DARWIN CITY COUNCIL

REPORT NO: 09TS0194 PL:lm

SUBJECT: DEVELOPMENT APPLICATION
LOT 6470 (100) ESPLANADE DARWIN CITY TOWN OF DARWIN
PROPOSED DEVELOPMENT - 21X1 54X2 AND 36X3 BEDROOM
MULTIPLE DWELLING AND SHOP IN A 14 STOREY BUILDING
INCLUDING 2 LEVELS OF BASEMENT CAR PARKING AND CAR
PARKING AT GROUND LEVEL AND LEVELS 1 AND 2

2866-SK01

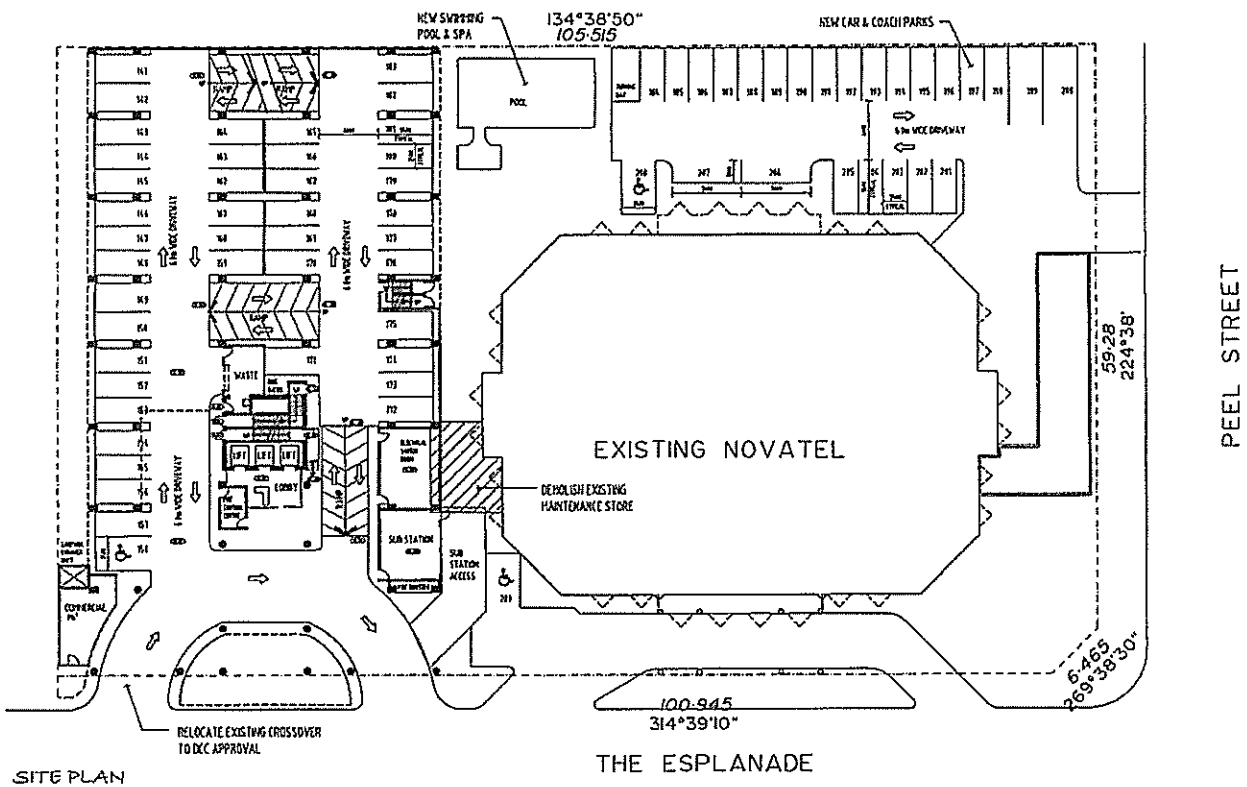
- a). **Council requests the Authority requires the applicant to provide an amended Site Plan which includes a loading bay for the Novotel building.** Clause 6.6 of the Planning Scheme requires on-site provision of a loading bay of minimum dimensions 7.5m (length) by 3.5m (width) for a motel and no loading bay is shown on the submitted plans. The 'Traffic Impact Study' prepared by 'i3 Consultants' advises that the parking area to the rear of the Novotel, accessed from Peel Street is intended for the Novotel's servicing and staff vehicles. The site plan (ref: 2866-SK01), prepared by Jackman Gooden Architects however, does not include a loading or service bay within the Peel Street parking area. The plan shows 23 car parking spaces of dimensions 5.5m (length) by 2.5m (width) and 2 larger bays of approximately 7.5m (length) by 3m (width). All of the 25 bays are required to meet the minimum Planning Scheme car parking requirements for both the Novotel and proposed residential building on the site.

- c). **The proposed crossovers and driveways for the Porte Cochere appear to meet Council requirements.** The applicant's Site Plan (ref: 2866-SK01), prepared by Jackman Gooden Architects, shows a 7m vehicle 'entry' driveway / crossover to the Porte Cochere from Esplanade and 7m vehicle 'exit' crossover / driveway to the Esplanade. However, the applicant will be required by Council to relocate any on-street car parking bays or motorcycle bays affected by the new vehicle access arrangements.

- e). Council notes that the site plan (ref: 2866-SK01), prepared by Jackman Gooden Architects, has a notation for 'new coach parks' for the Novotel within the Peel Street parking court, but does not indicate on the plan where these will be located. With the exception of the Porte Cochere area, there does not appear to be a location on the Novotel site of sufficient dimensions for bus / coach parking. The Byrne Design and Drafting Coach Turning Path plan (ref: 1114_SK2) indicates that a standard bus / coach is 14.5m (length) by 2.5m (width).

2866-SK04

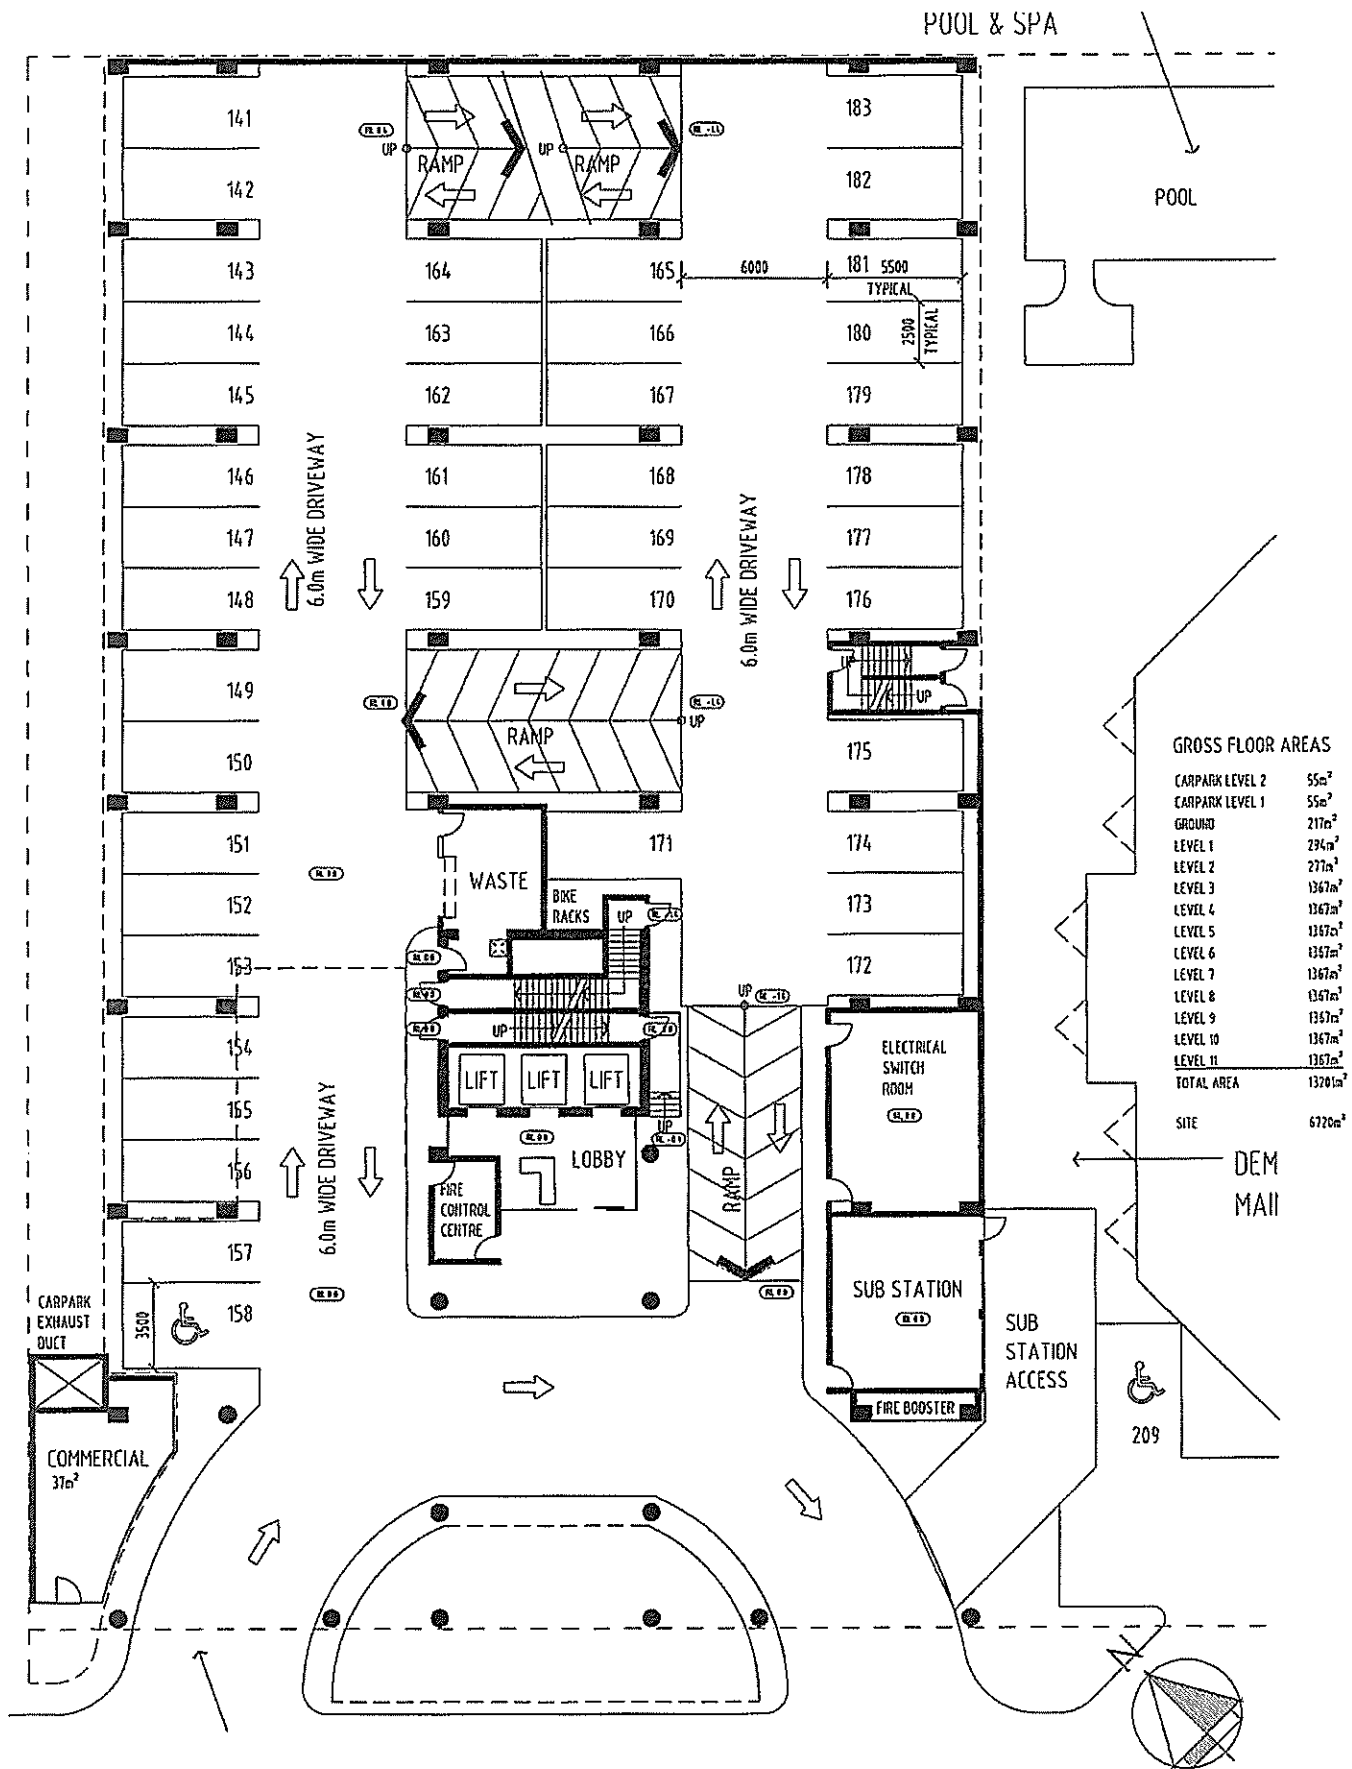
- d). **The waste management and waste collection services for proposed development appear to meet Council's requirements.** The development application plans (ref: Jackman Gooden Architects - 2866-SK04 Ground Floor Plan) include a waste bin enclosure (approximately 5m (length) by 3m (width) and a waste chute extending to the 11th floor of the building. The applicant has also provided a Preliminary Garbage Truck Turning Path Plan (ref: Byrne Design and Drafting - 1114_SK2).
